# Access Compliance Report

## Public Rights-of-Way

Intersection ID: 48949	Main Street: OLD_STONE_CROSSING_DR	Cross Street: DAVID_JENNINGS_AV	Location: NW
ADA ID: 7DE0AB57B4F4	Ramp Type: Combination1	Initial Pass/Fail: Fail	Overall Compliance: No
			Severity Score: 33.75

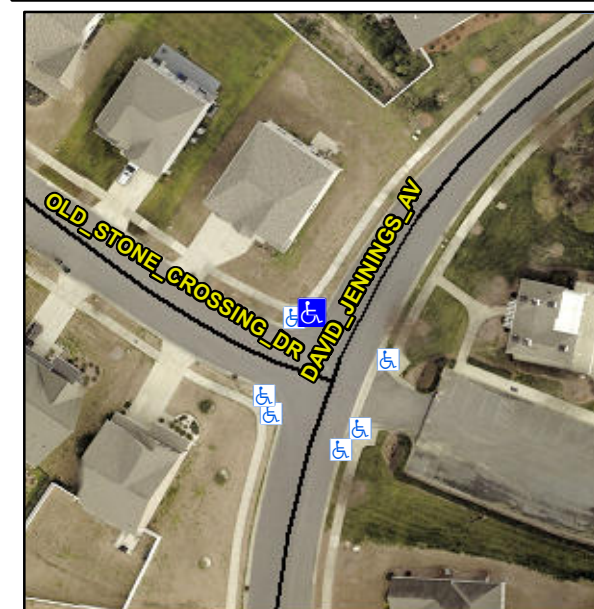
**Not Found, R304.5.1, R304.5.3, R304.3.2**

Compliance	Description	Data	Compliance	Description	Data
N/A	Ramp Length LT (in)	N/A	N/A	Ramp Length RT (in)	1.0
Yes	Ramp Width LT (in)	60.0	Yes	Ramp Width RT (in)	60.0
No	Ramp Slope LT (%)	8.6	No	Ramp Slope RT (%)	10.4
Yes	Ramp XSlope LT (%)	1.6	No	Ramp XSlope RT (%)	3.6
N/A	Ramp Length (in)	72.0	Yes	Ramp Slope (%)	1.7
No	Ramp Width (in)	47.0	No	Ramp XSlope (%)	5.6
N/A	Flare Type LT	N/A	N/A	Flare Type RT	N/A
N/A	Flare Slope LT (%)	N/A	N/A	Flare Slope RT (%)	N/A
N/A	Flare Traversable LT?	N/A	N/A	Flare Traversable RT?	N/A
N/A	Landing Length (in)	N/A	N/A	DWS Provided?	N/A
N/A	Landing Width (in)	N/A	N/A	DWS Contrast?	N/A
N/A	Landing Slope (%)	N/A	N/A	DWS Length (in)	N/A
N/A	Landing X Slope (%)	N/A	N/A	DWS Full Width?	N/A
N/A	Landing Curb? (Y/N)	N/A	N/A	DWS Offset (in)	N/A
N/A	Shared Landing?	N/A			
N/A	Gutter Ponding?	N/A	N/A	Gutter Slope (%)	N/A
N/A	Gutter Lip Ht (in)	N/A	N/A	Gutter X Slope (%)	N/A
N/A	Painted X Walk1?	No	N/A	Painted X Walk2?	N/A

**Remove & Replace Entire Ramp.**
